PROJECT SOURCE NAME:CITRUS CO. CENTRAL LANDFILL (MOD)

Your application for a permit remains incomplete. Please provide the information listed below promptly. Evaluation of your proposed project will be delayed until all requested information has been received.

The purpose of this correspondence is to provide the additional requests in your letter dated November 20, 1995 to renew the Phase 1 operating permit for the Citrus County Central Landfill. Your requests for additional information are restated below with our response.

**FIGURE 1**  
Site Plan

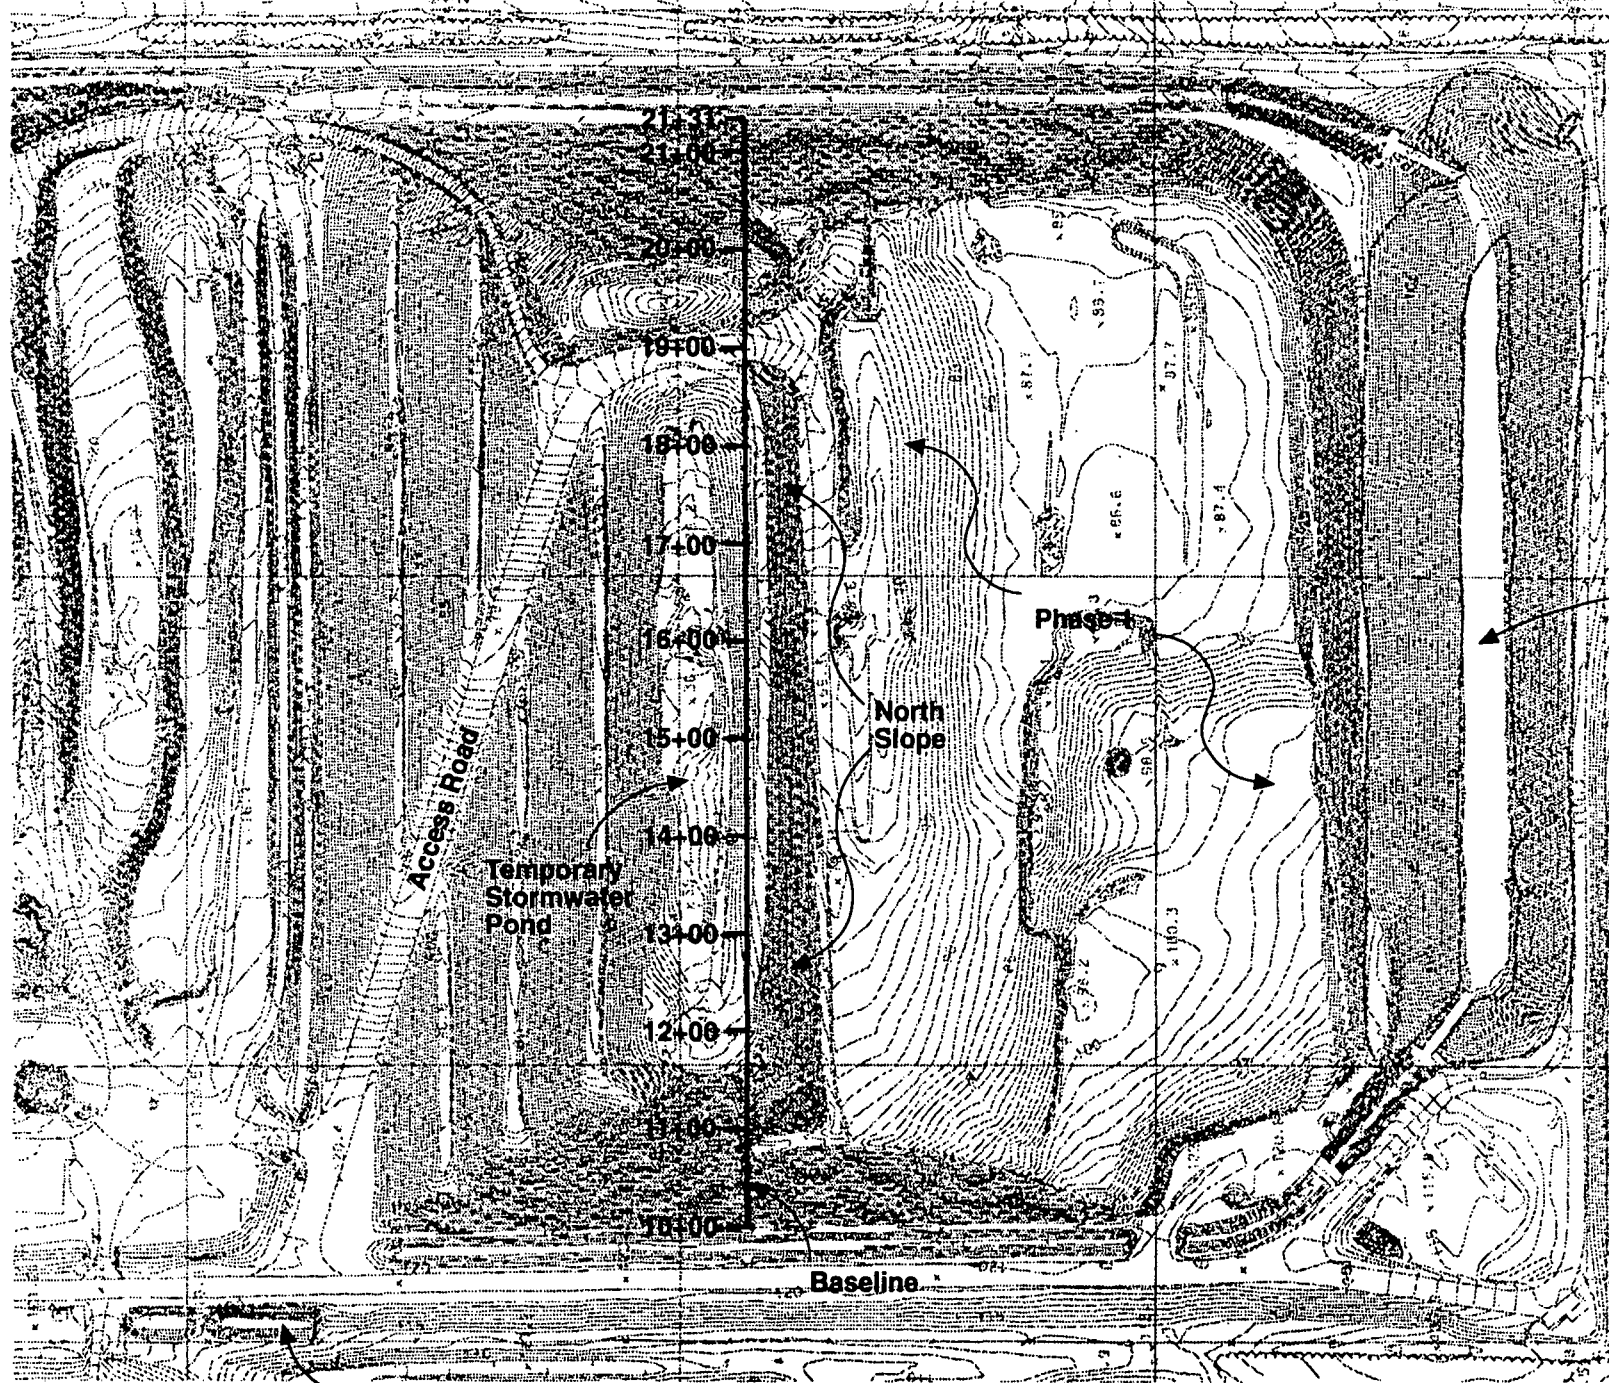
*The north slope of the landfill appears to have been filled to elevations above those shown in the Phase I permit drawings (Section A on Sheet 17). A site plan of the landfill with the north slope identified is shown in Figure 1. Also shown in Figure 1 is a baseline north of the isolation berm at the toe of the northern slope. Figure 2 shows a cross section through the northern slope at Station 16+00 along the baseline. Also shown in Figure 2 is the planned limits of future filling at the northern slope of Phase I. Attachment D includes a technical memorandum prepared by Gary L. Panozzo of CH2M Hill which evaluates the existing stability of the waste mass along the landfill lining at the north slope and the stability of the planned completed Phase I. The technical memorandum concludes that the north slope is stable considering failure surfaces along the lining under existing and final conditions.*
